**NOTIFICATION OF ADDENDUM
ADDENDUM NO. THREE
DATED: May 2, 2022**

**Parmer Ranch Blvd Phase 2 and Parmer Ranch Off-Site Wastewater Interceptor - Phase B
City of Georgetown Williamson County, Texas**

- Sheets 3, 33, 45, 49 and 77 from the Parmer Ranch Blvd Phase 2 - Bid Set were Revised
- No Sheets from the Off-Site Wastewater Interceptor - Bid Set were Revised

GENERAL NOTES (2 OF 2)
PARMER RANCH BLVD PHASE 2
City of Georgetown
Williamson County, Texas
Project Number: 22223-Phase 04
SCALE: AS NOTED
Project Path: P\22000-22999\22223
Project Name: Parmer Ranch
Drawing Path: CAD\Plans
Xref DWG FILE:
Sheet Number 03 of 110 sheets

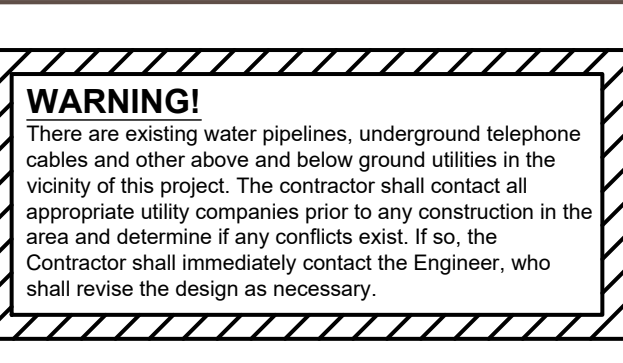
Table with 4 columns: NO., REVISION, BY, DATE. Row 1: 2, UPDATED WW PIPE LINEAR FEET, TG, 5/02/22

STRM B101 PLAN & PROFILE
PARMER RANCH BLVD PHASE 2
 City of Georgetown
 Williamson County, Texas

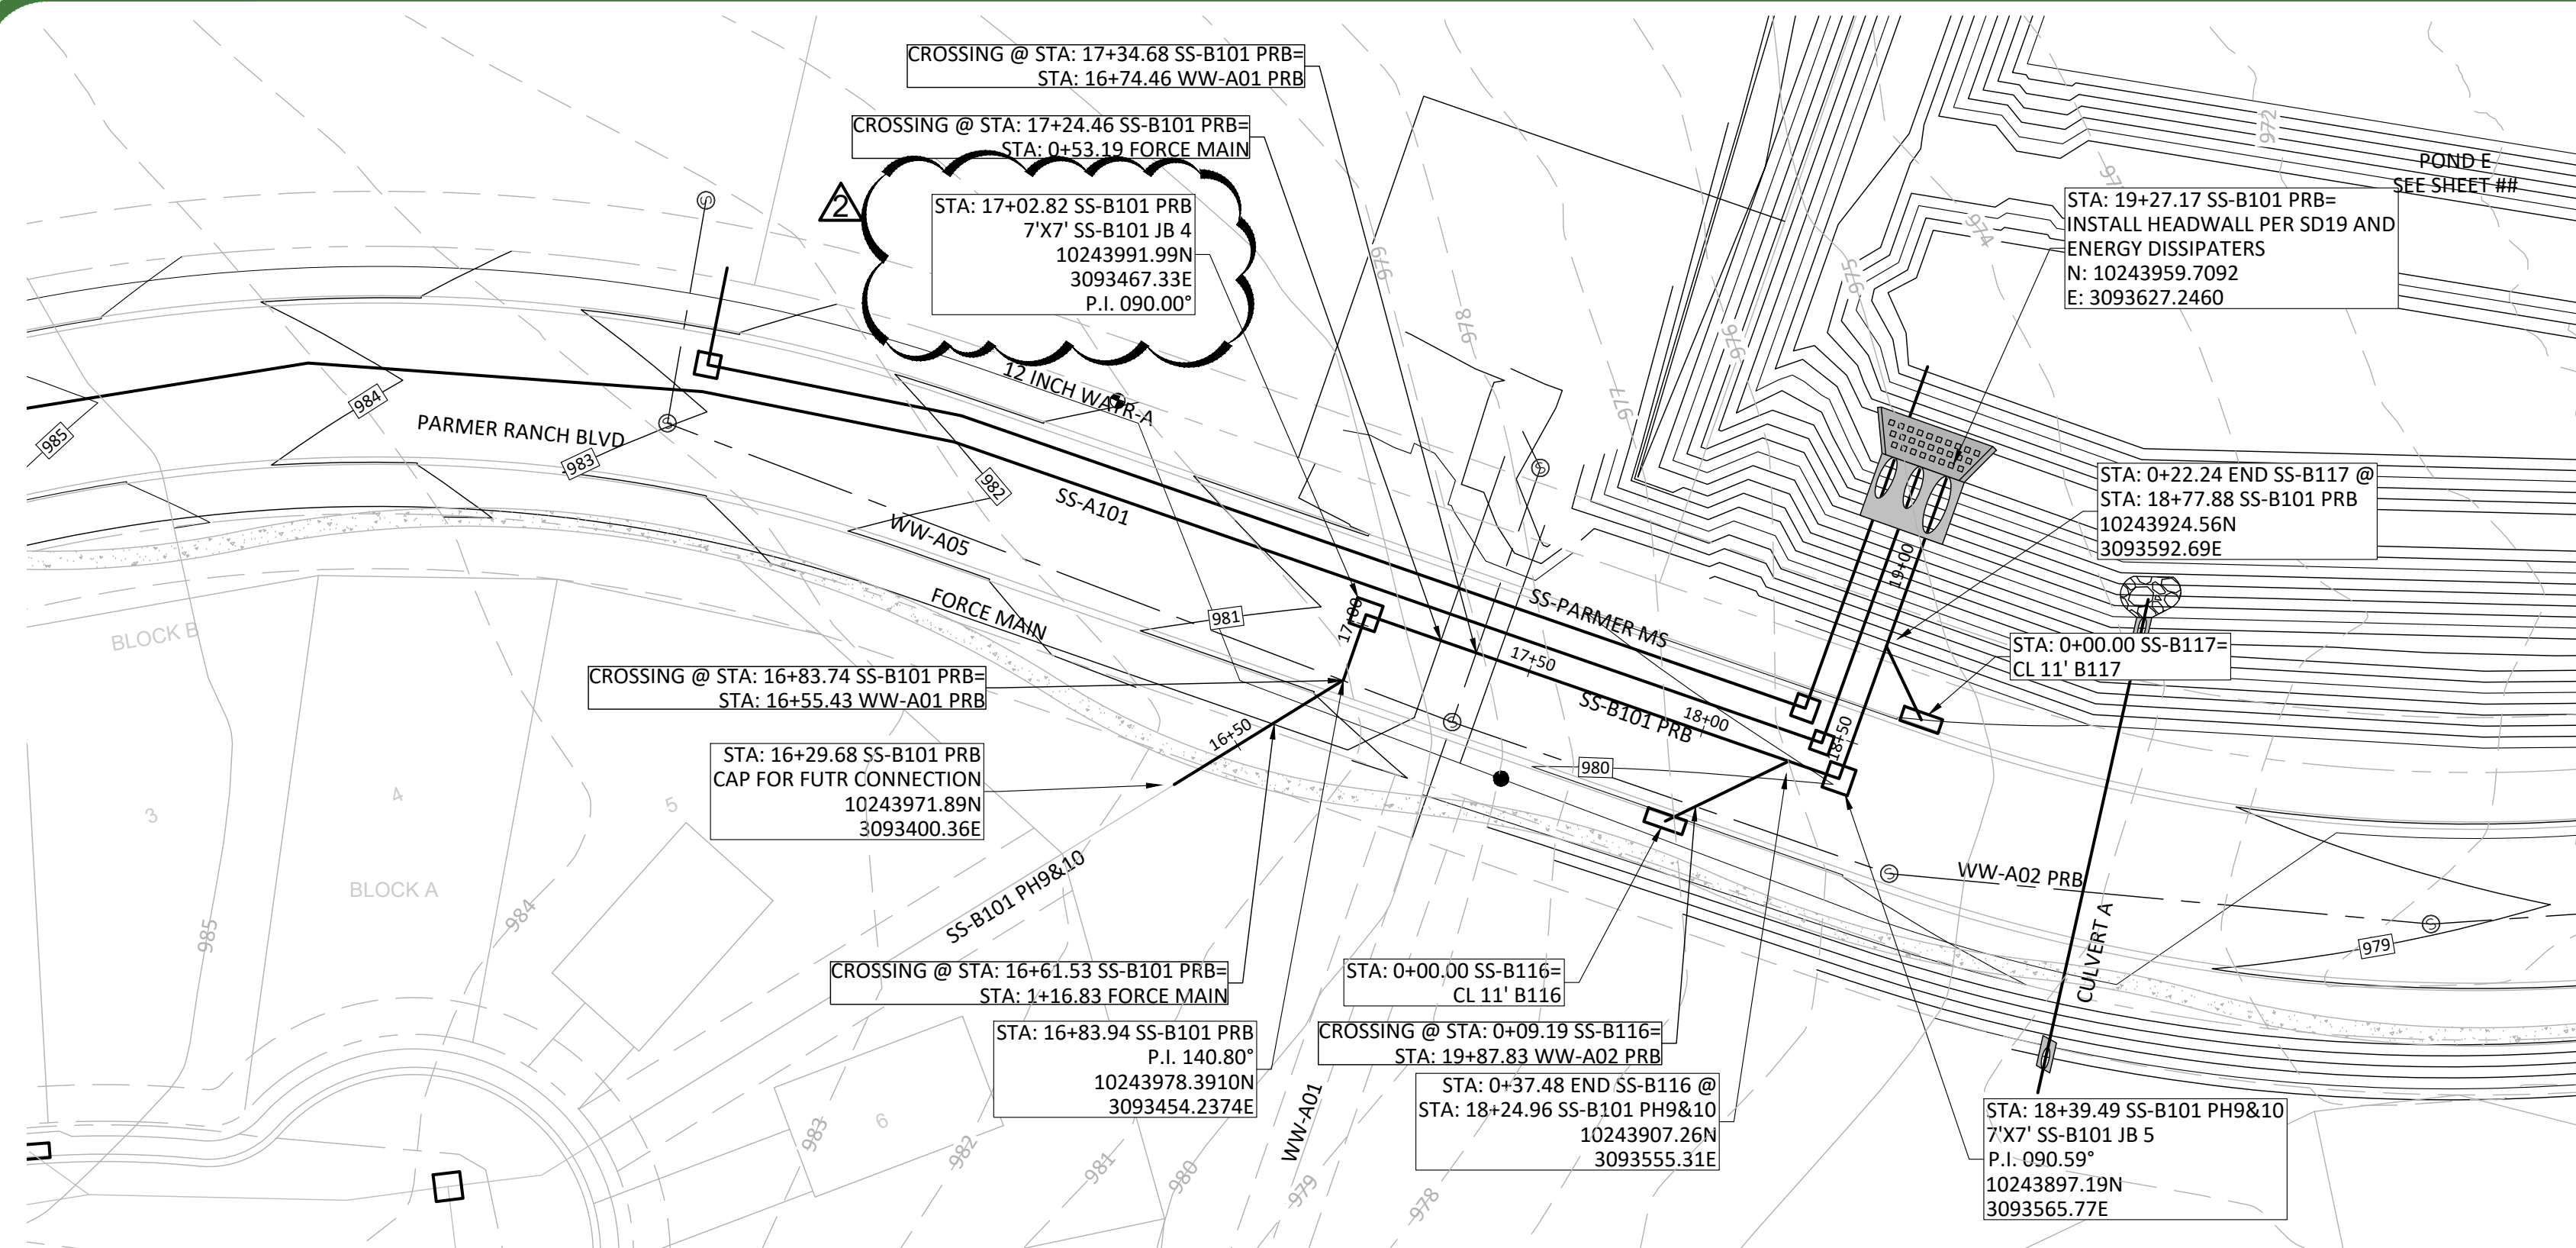
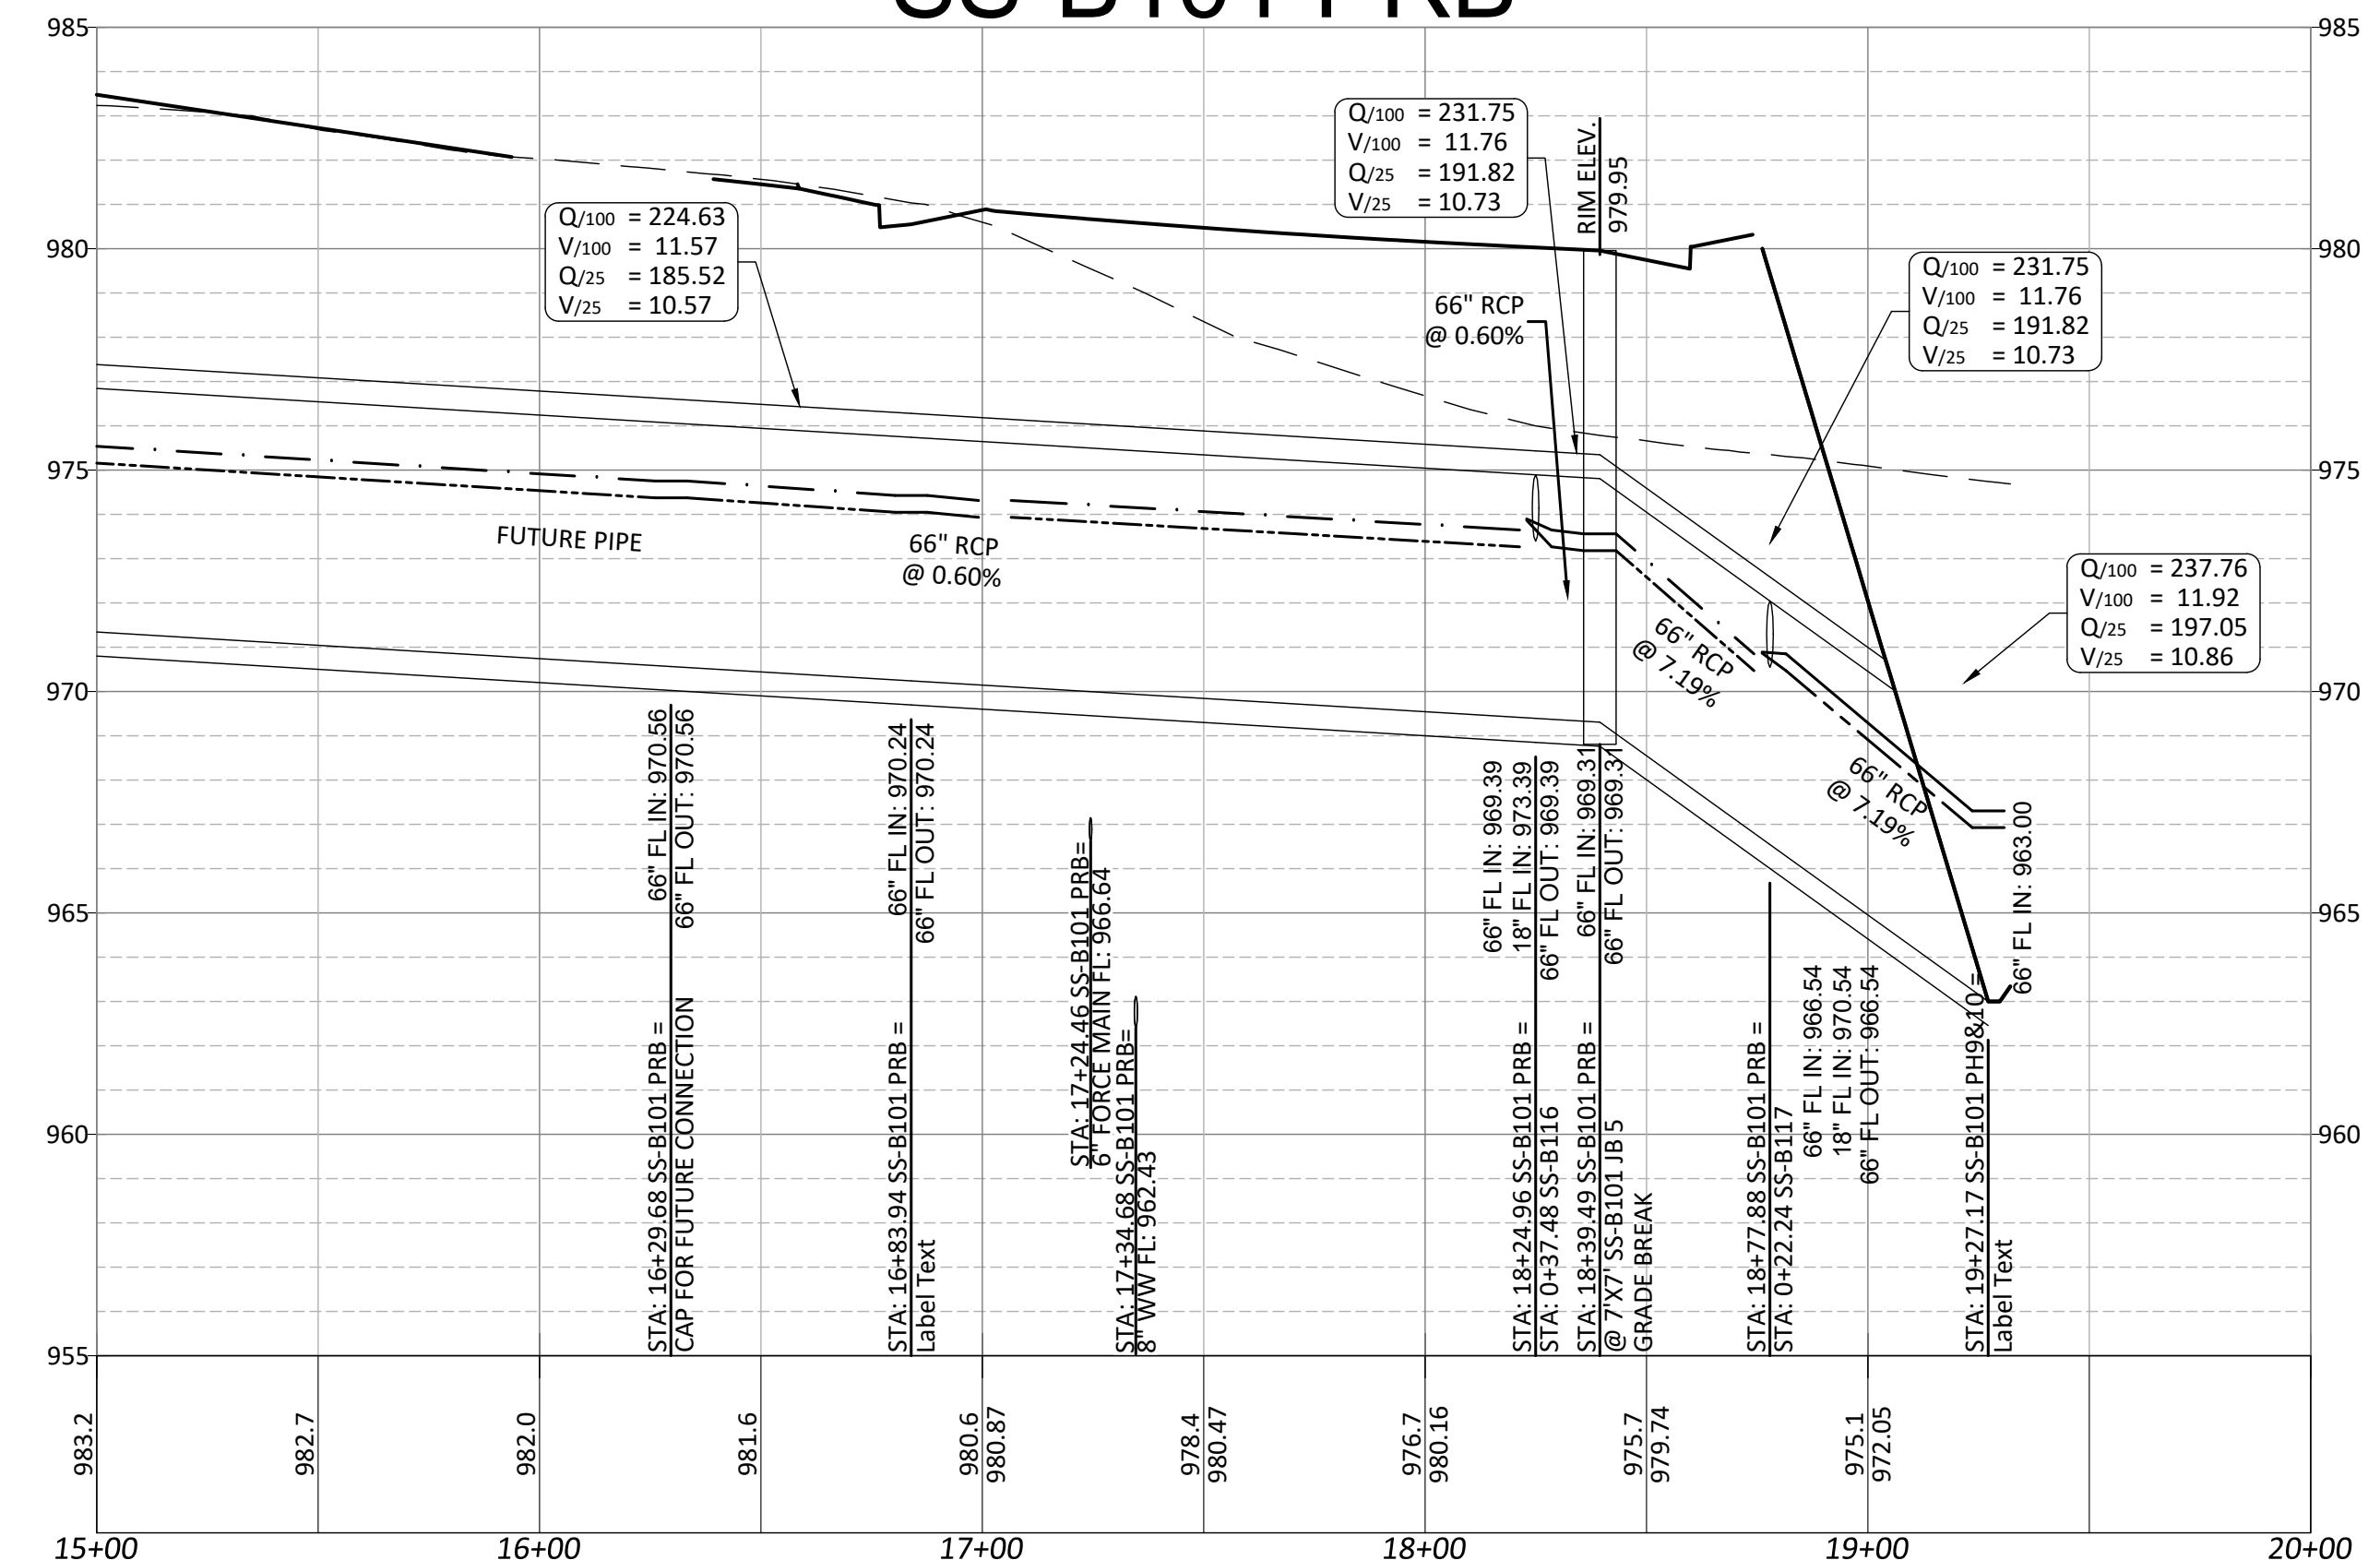
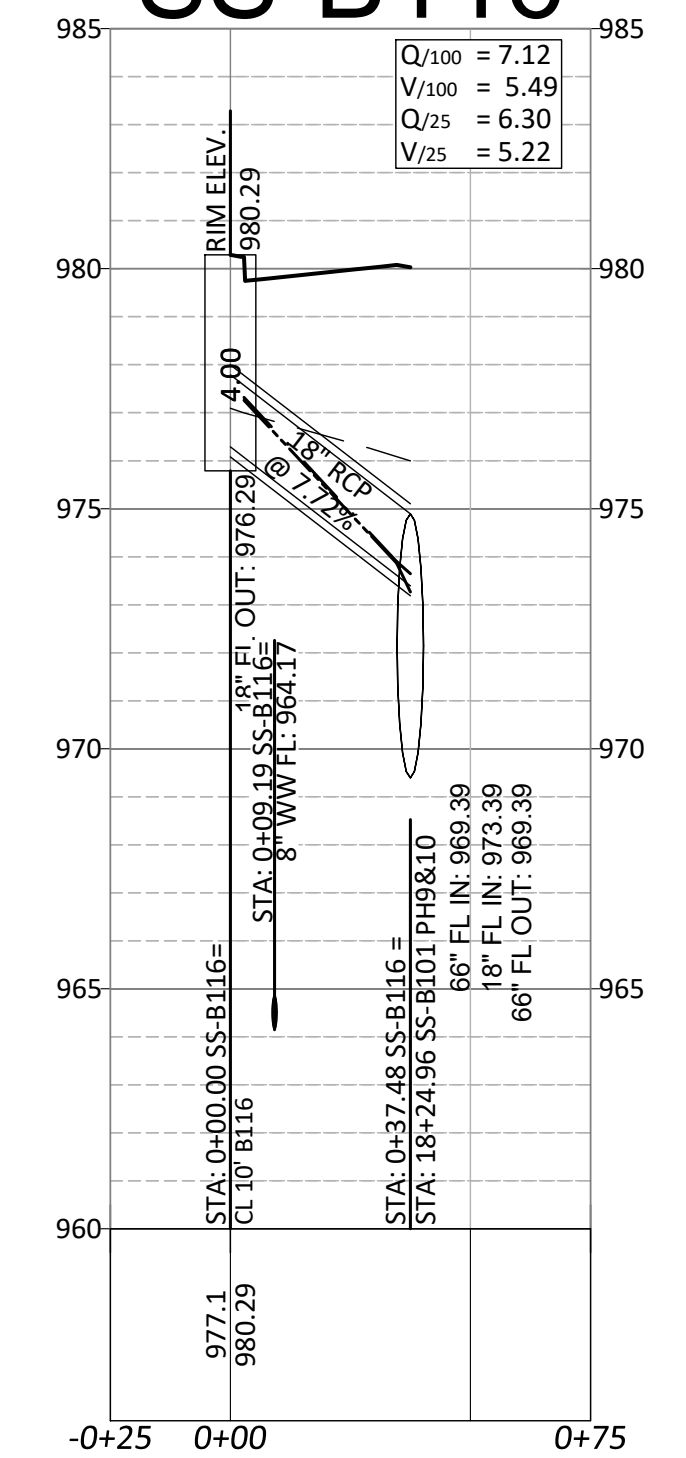
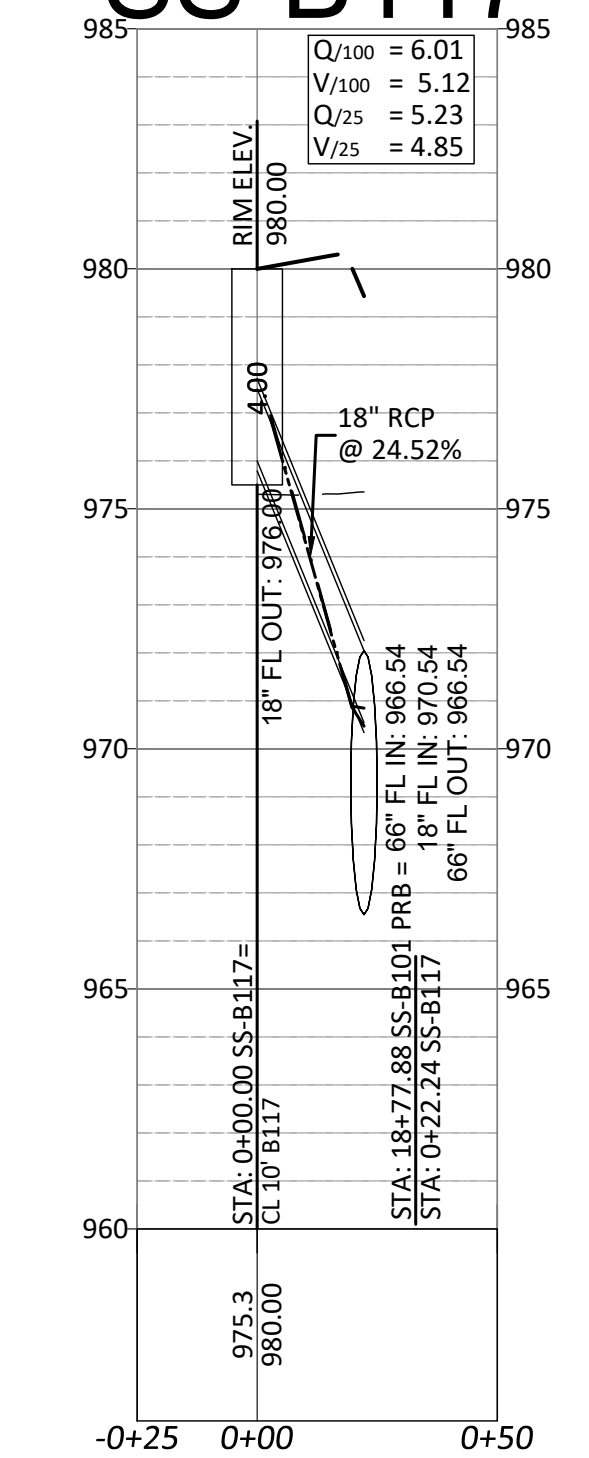
17. There is a structure drawn on sheet 33 that is not labeled. Is this the other 7'x7' Junction Box?
Yes, the sheet has been updated to include the proper label.

NO.	REVISION	BY	DATE
2	ADDED MISSING LABEL	TG	5/02/22
